**Re: 703-723 W. Algonquin Rd – PUD Amendment – Amendment to PUD Ordinance 18-014 PC#20-016
– Round 3**

The following is our Planning Commission response Letter addressing the comments as outlined in the Village of Arlington Heights Building & Life Safety Department Interoffice Memorandum regarding the aforementioned project:

Planning & Community Development Dept. Review Round 2 Comments

Civil Engineering ♦ Real Estate Consulting ♦ Project Management

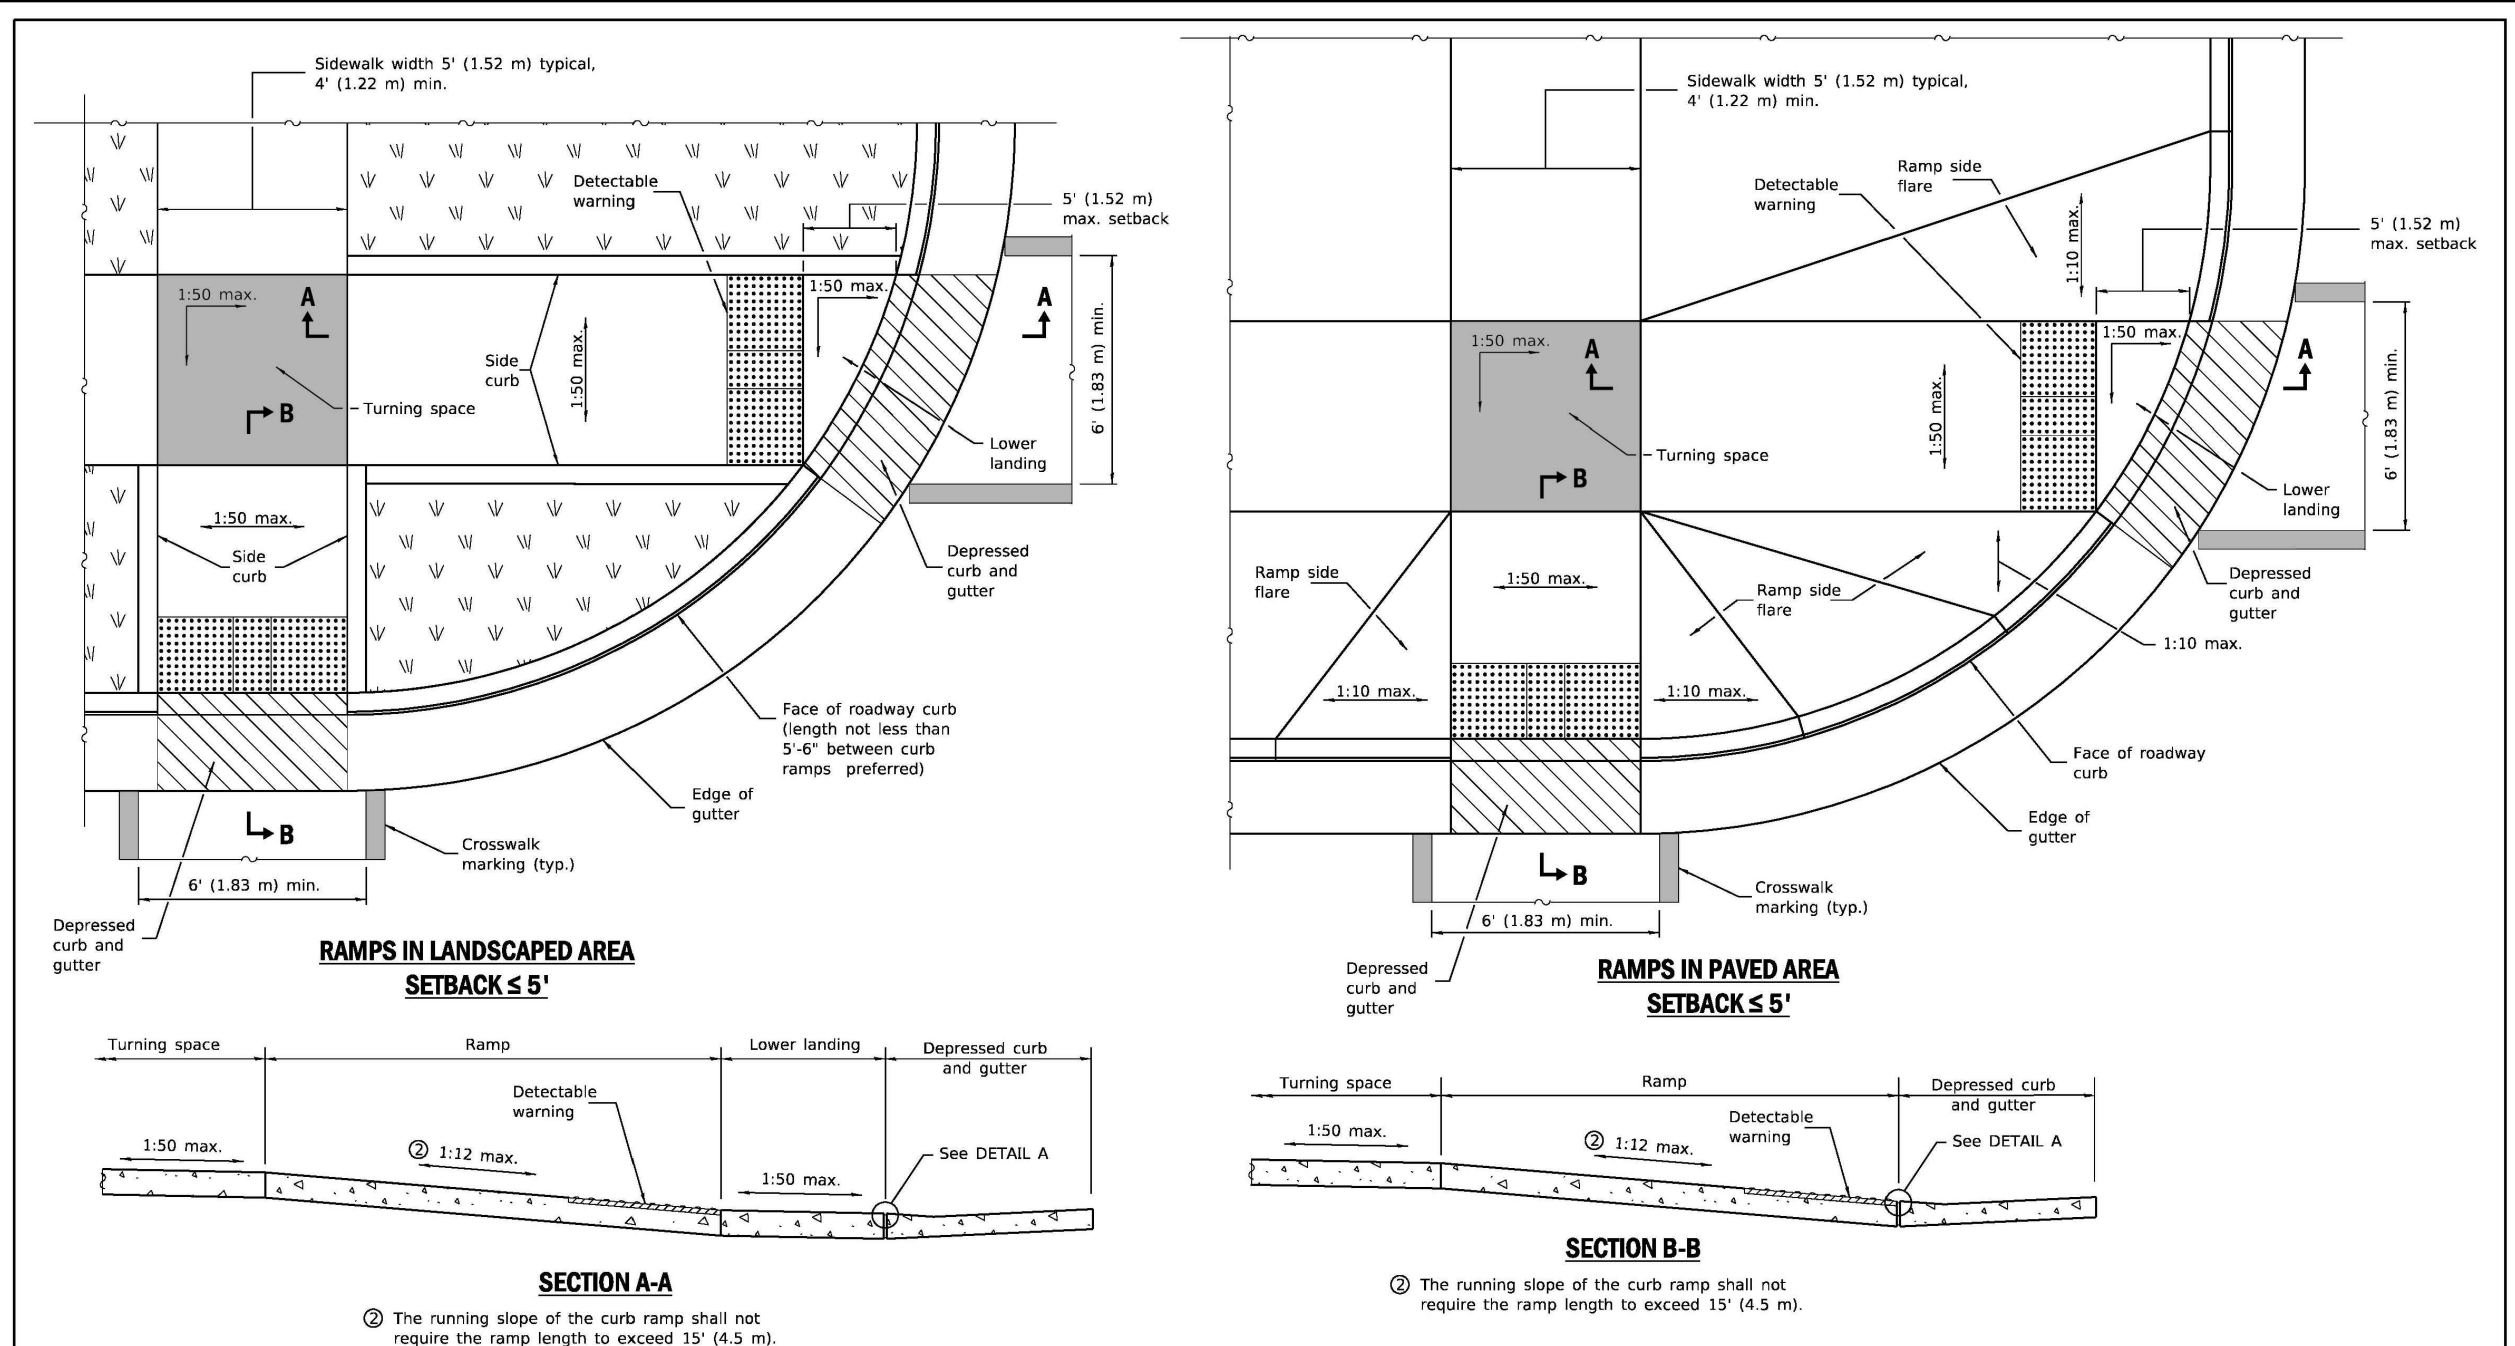
43. **Response:** Noted: See Truck Routing/Turning plan (Exhibit E). Plan shows requested information for the southernmost truck dock. Also includes ingress and egress info while truck and trailer is parked in the adjacent space.

Exhibit F

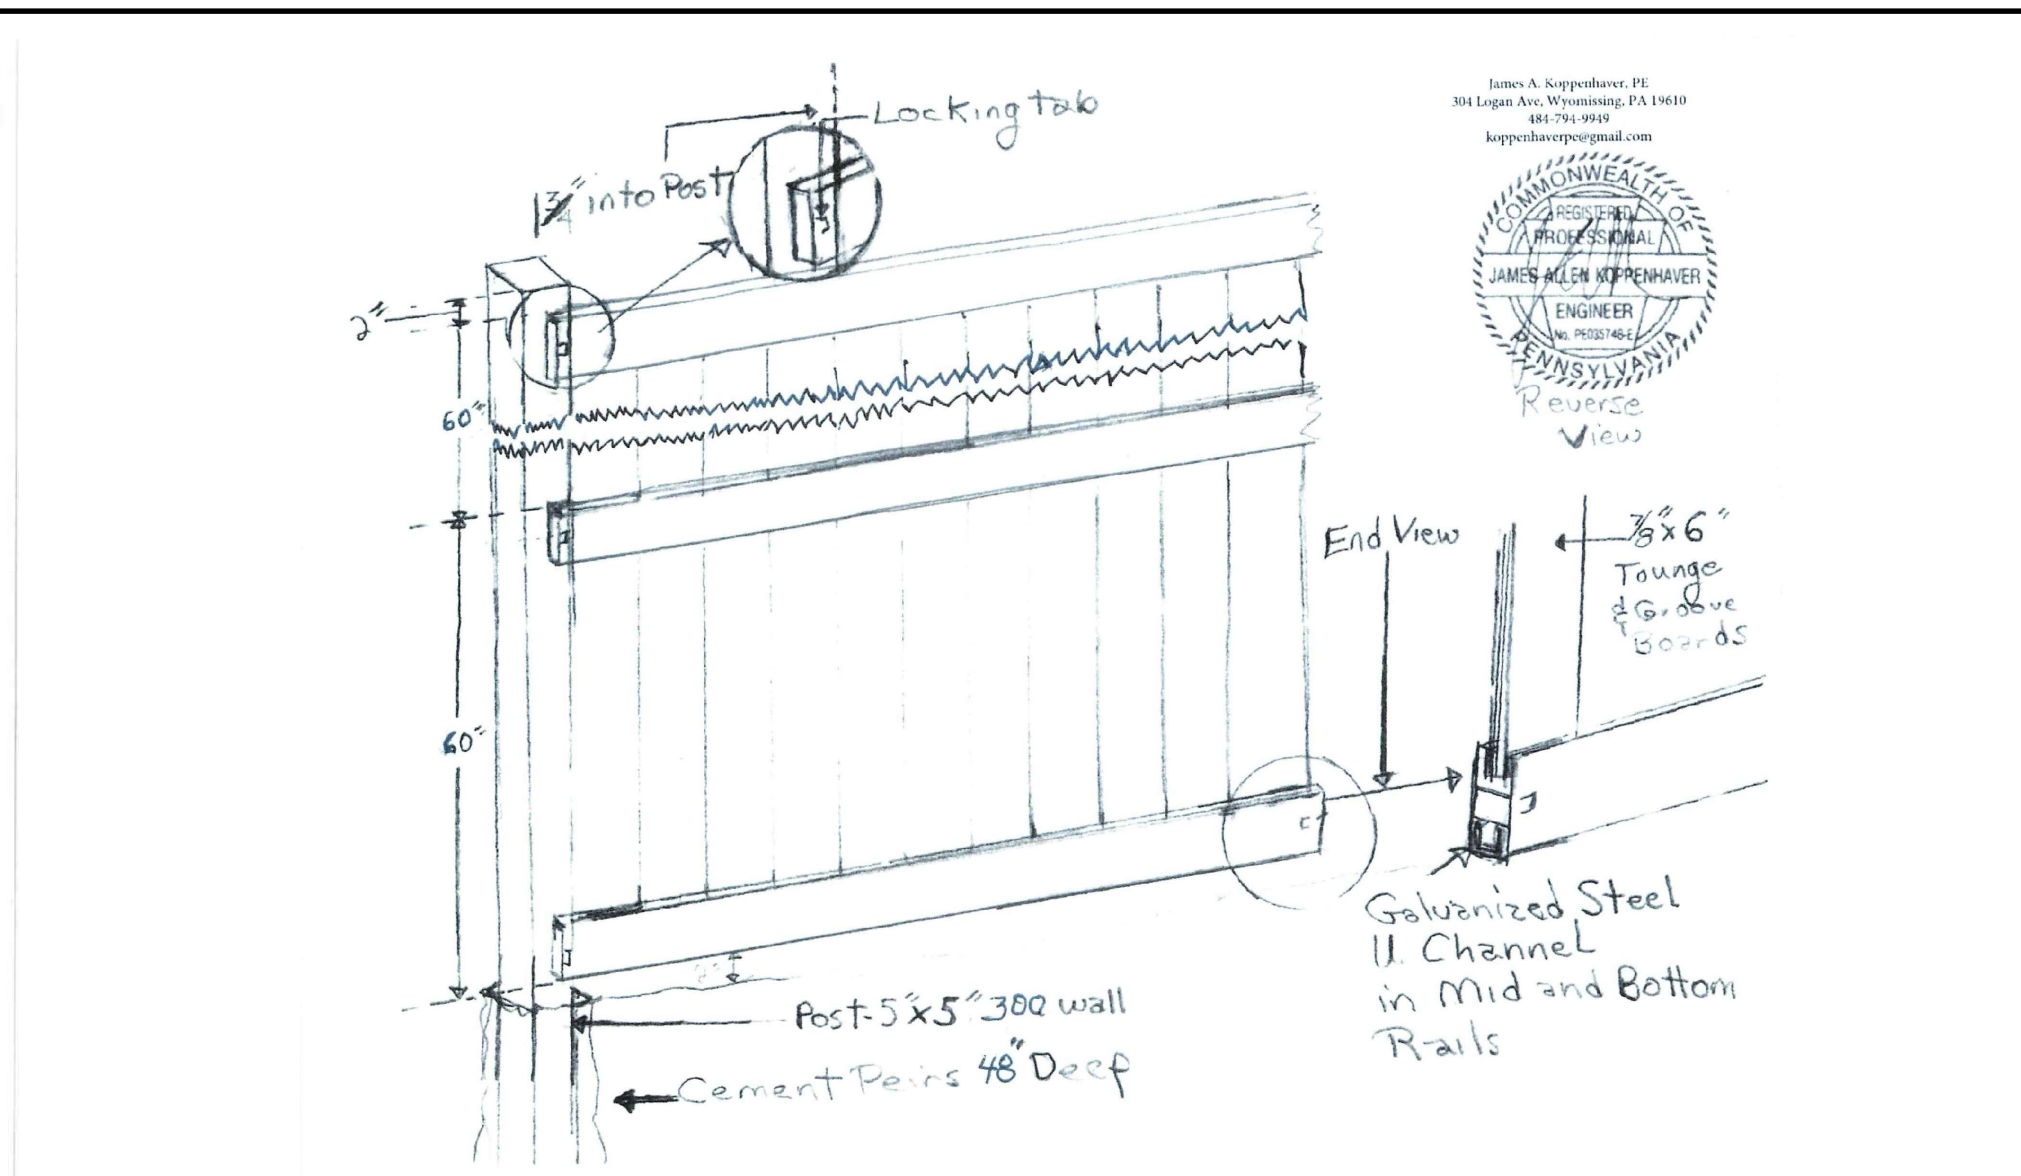
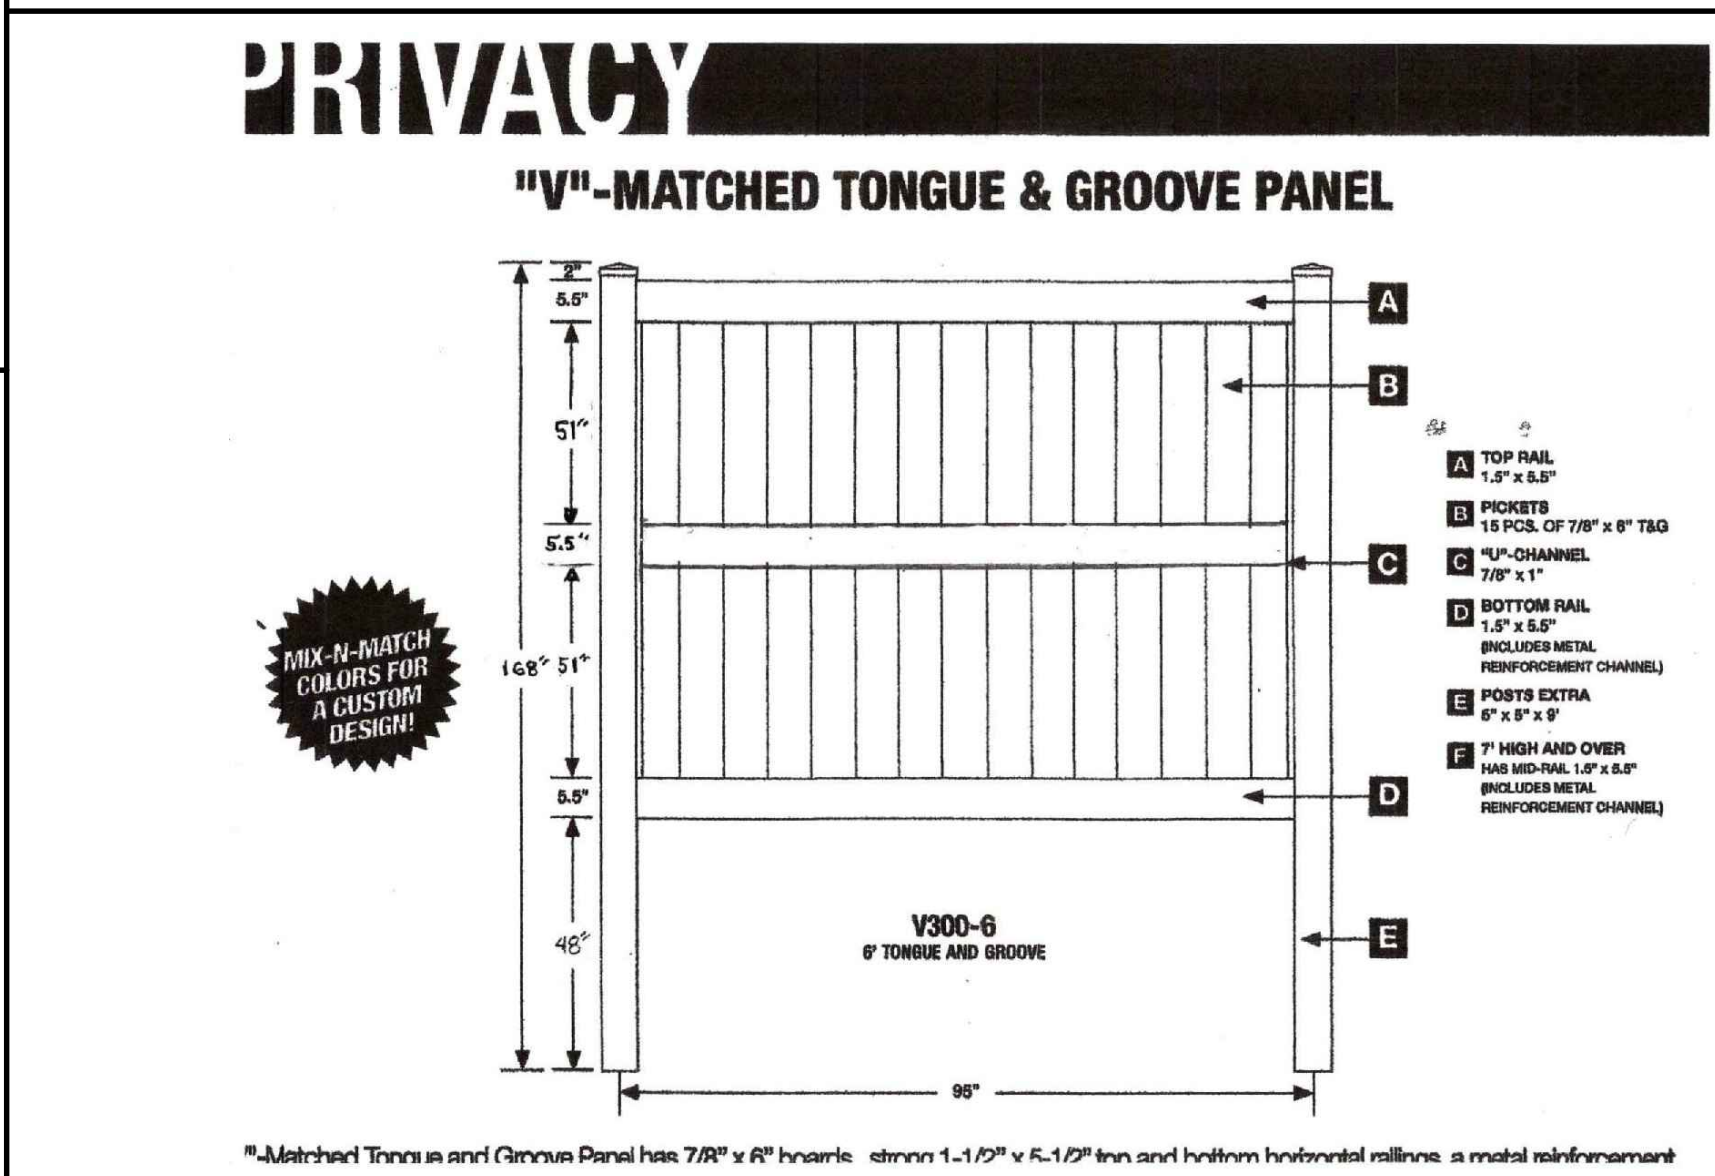
37. Response: Noted: Updated Construction Standards Plan (Exhibit F). Plan provides detail on revised fencing spec (height, style, material).

Exhibit H

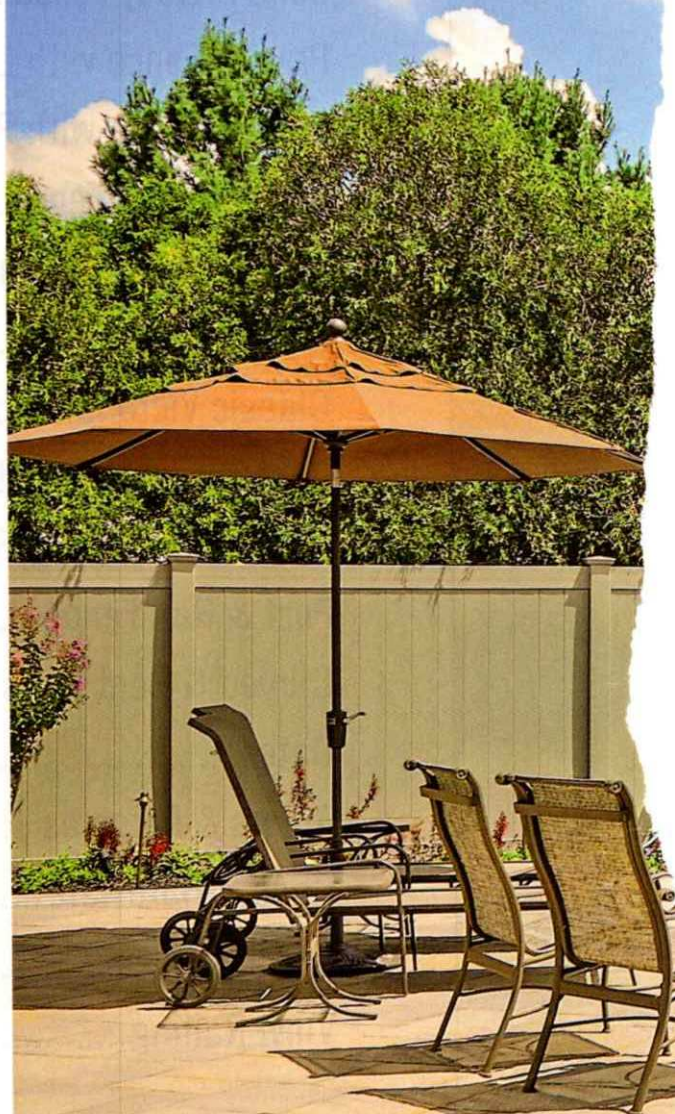
3. **Response: Noted: Landscape plan (Exhibit D) and civil plan (Exhibit F) updated per request. This plan shows new 10-foot vinyl fence along southern property line. Color to be beige, gray, or clay (Exhibit H).**
